Re: Potrero Power Plant Unit 7 Project: CEC Docket No. 00-AFC-4

**RESPONSES TO CEC DATA REQUESTS 216-253 (SIXTH SET), SAEJ
AND OCE DATA REQUESTS 1-49 (THIRD SET), AND CBE DATA
REQUESTS 1-68 (SECOND SET), ON THE COOLING TOWER SYSTEM
AMENDMENT TO APPLICATION FOR CERTIFICATION (00-AFC-4),
POTRERO POWER PLANT UNIT 7 PROJECT**

CEC FIGURE 220-1

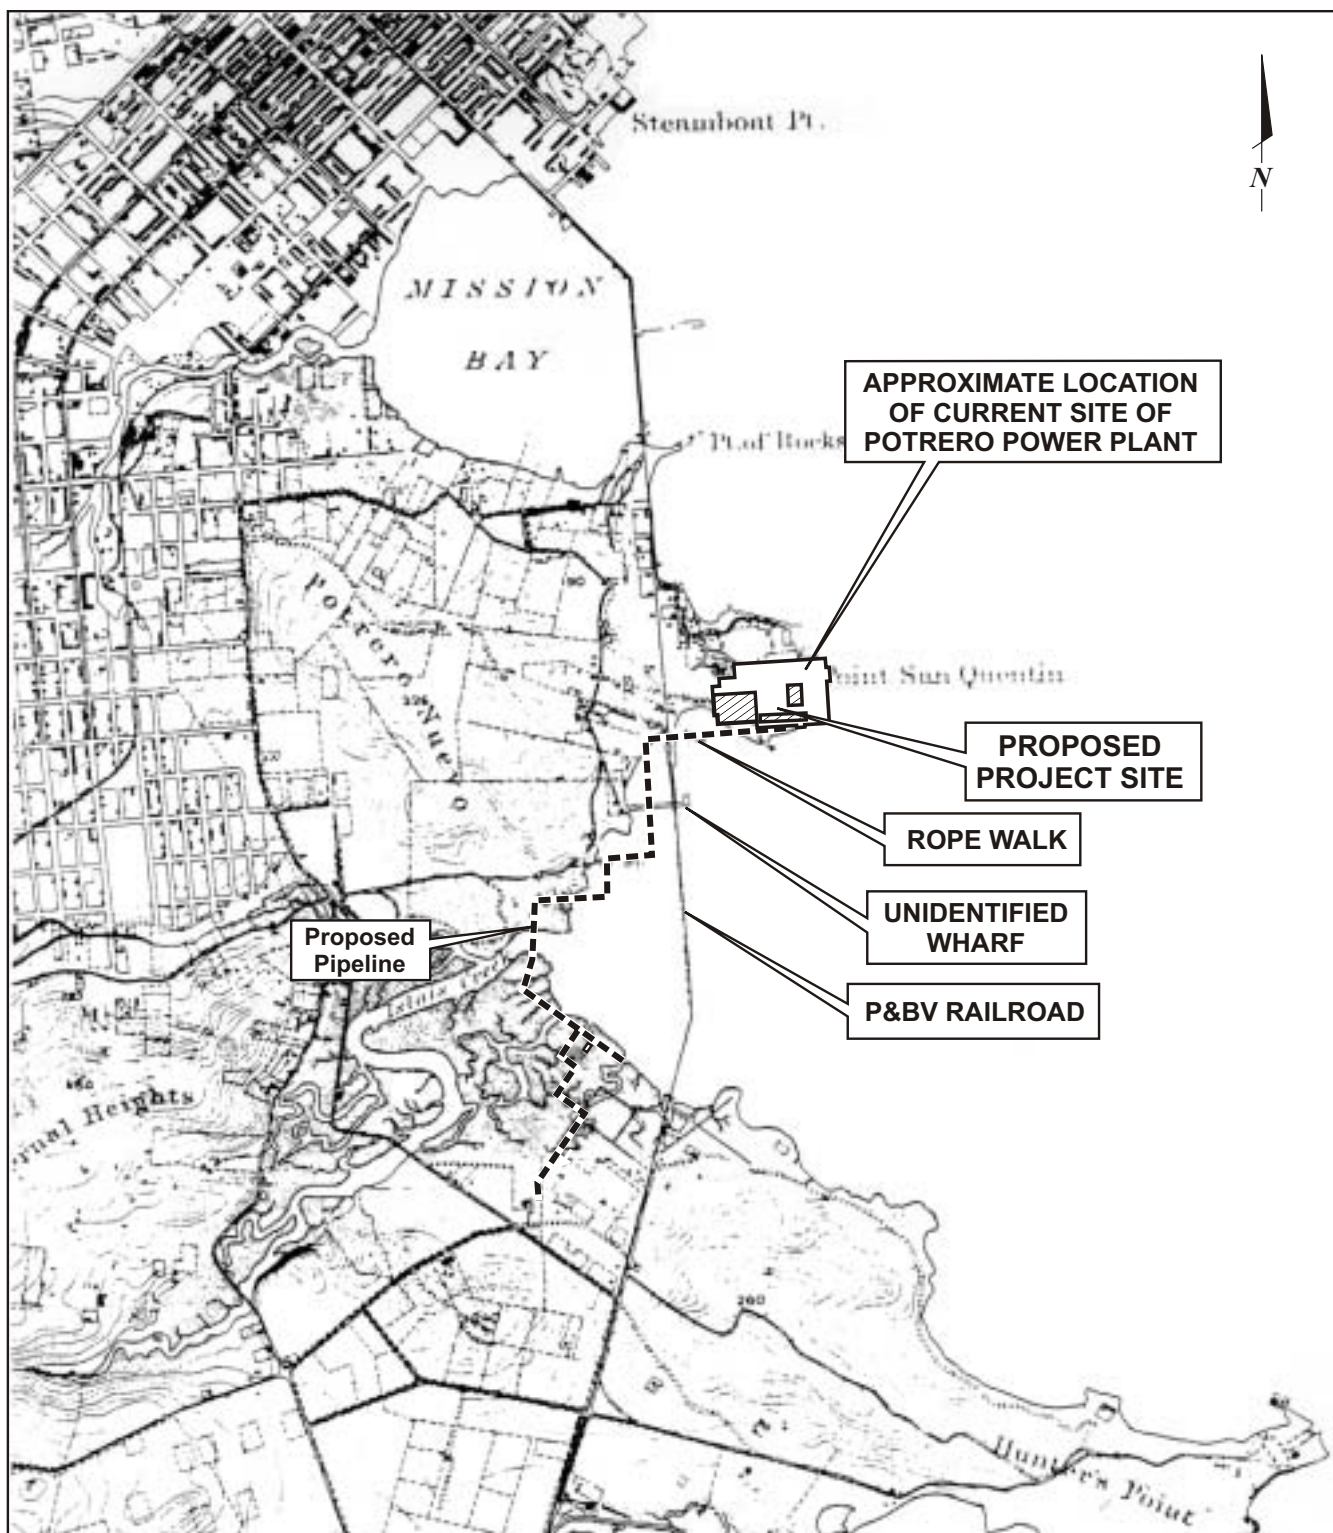
- 220. Please provide a literature review and consult historic maps to identify potential subsurface cultural resources that could be impacted by the proposed pipelines. The literature review should include, but not be limited to, the following:**

The route of the underground pipeline upon leaving the plant would follow the 24th Street alignment westward for a distance of three blocks to Minnesota Street. Along this section, the route appears to be situated within fill between Illinois and Third streets and then upon native soils westward to Minnesota Street. The change from fill to native soils represents the undulating, southern edge of Potrero Point that ultimately transitions into the mainland at approximately Third Street (Figure 220-3).

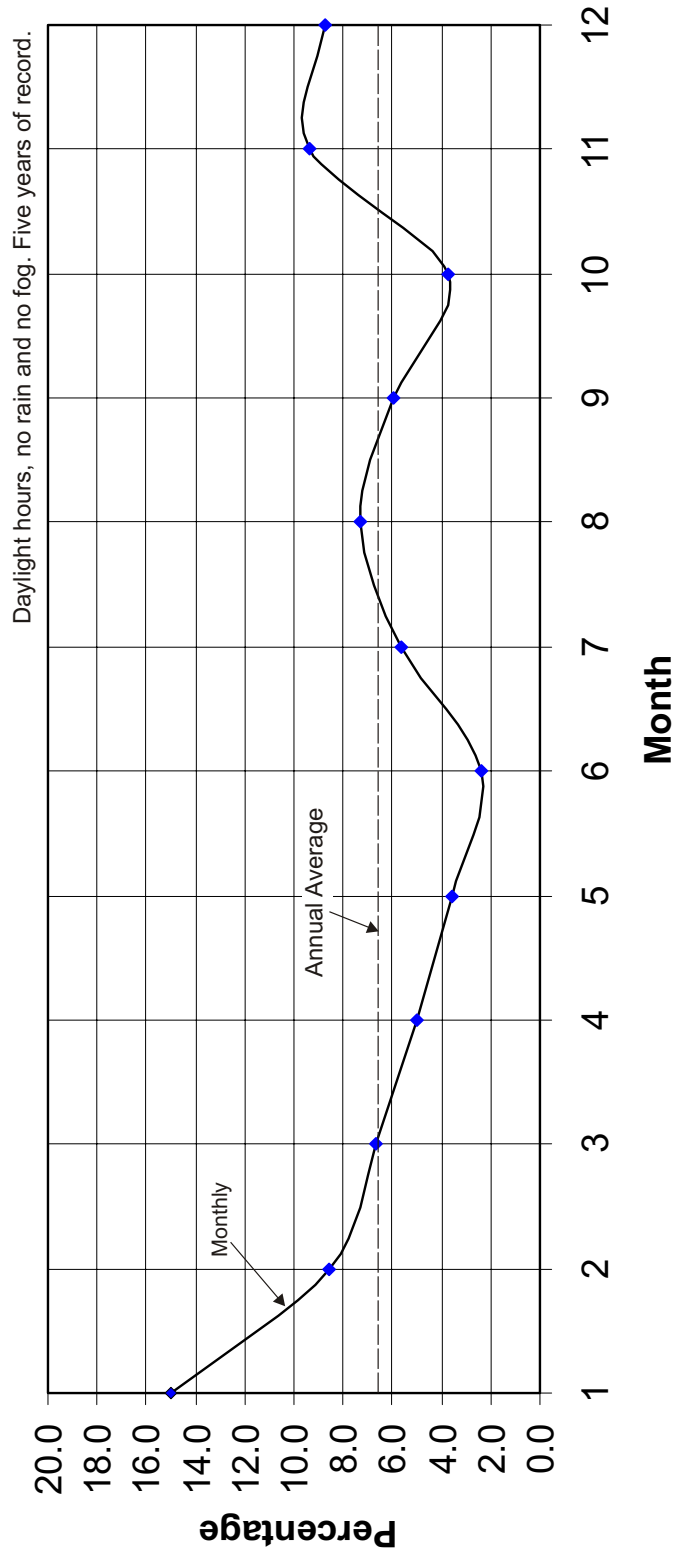
249. *Please provide a plume fogging frequency curve for the specified plume abated tower design.*

The plume fogging frequency for the daylight hours with no rain and no fog for the five-year period of meteorological data is shown in CEC Figure 249-1.

SAE/JOCE FIGURE 9-1

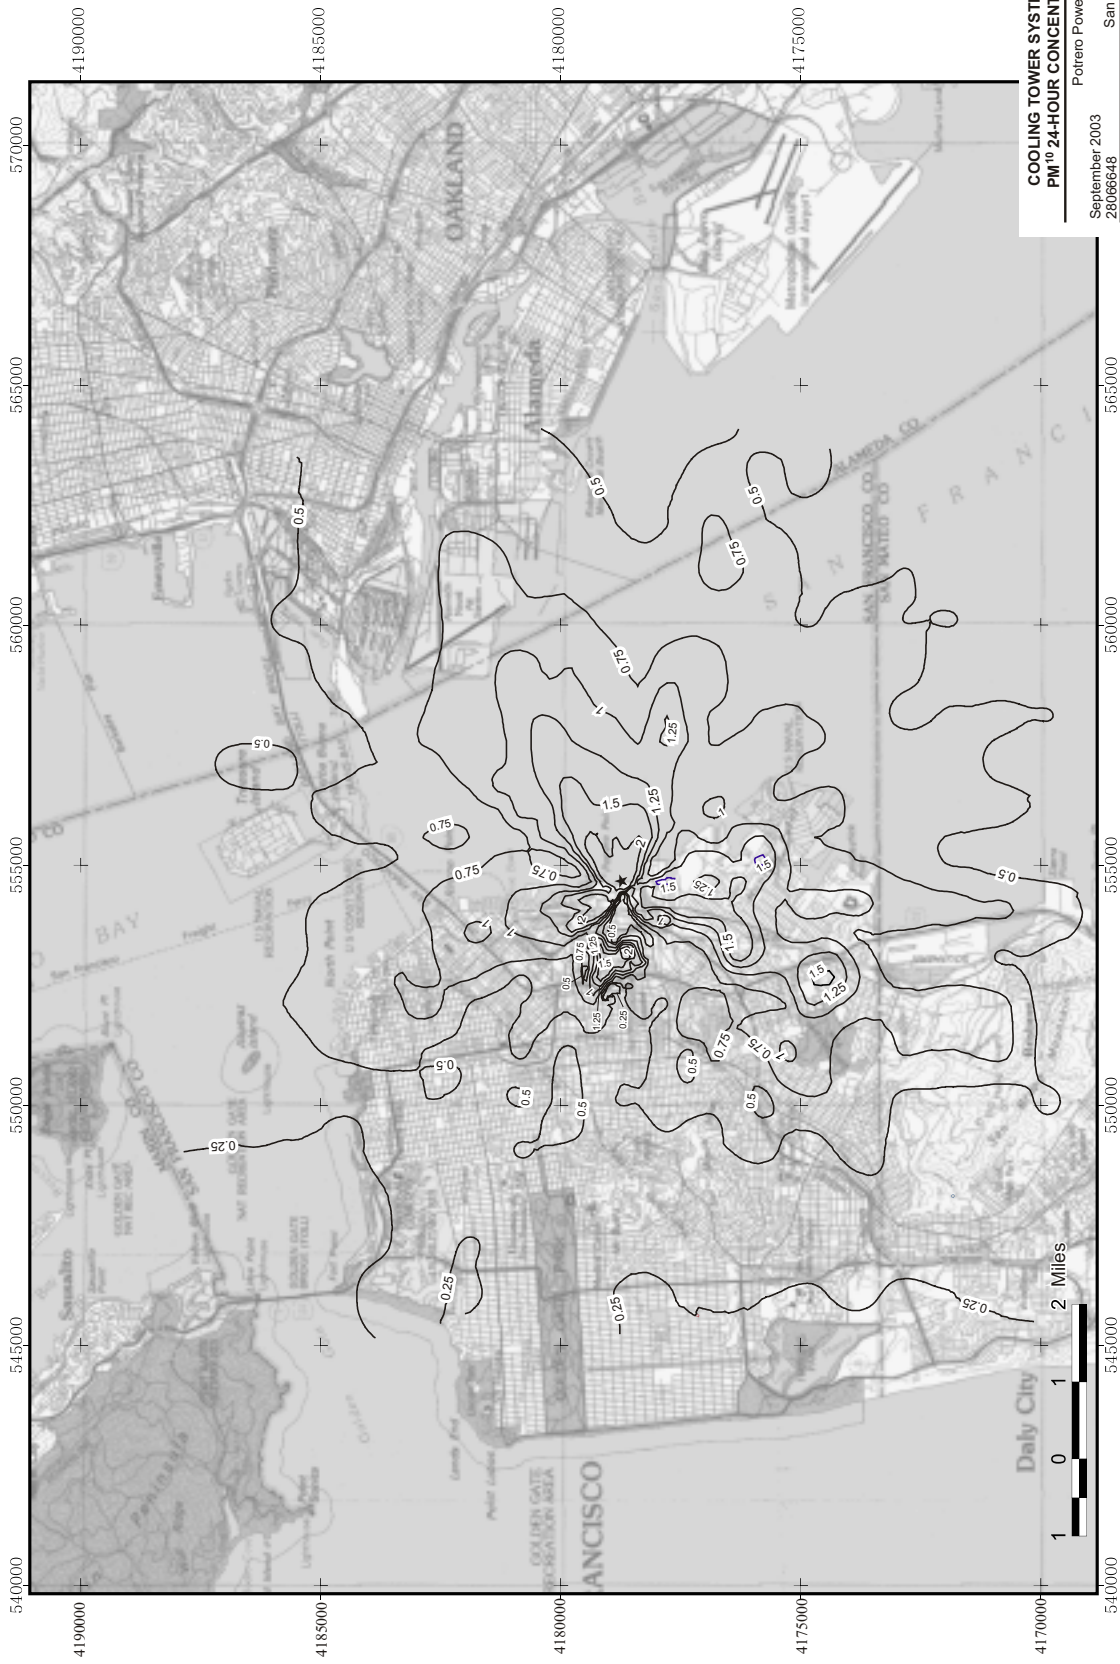
9. *Please provide a plume map documenting the distribution of PM_{10} and $PM_{2.5}$ emissions from the cooling tower and the turbines.*

The 24-hour and annual PM_{10} (and $PM_{2.5}$) lines of equal concentration (isopleths), based on modeling results that included emissions from the turbines and the cooling tower, are shown in SAEJ/OCE Figures 9-1 and 9-2, respectively. SAEJ/OCE Figure 9-1 shows the modeled distribution of maximum PM_{10} 24-hour concentrations at each receptor location. SAEJ/OCE Figure 9-2 shows the modeled distribution of PM_{10} for the annual period. The star in each figure shows the location of the maximum concentration modeled, which in both cases is located near the eastern edge of the facility.
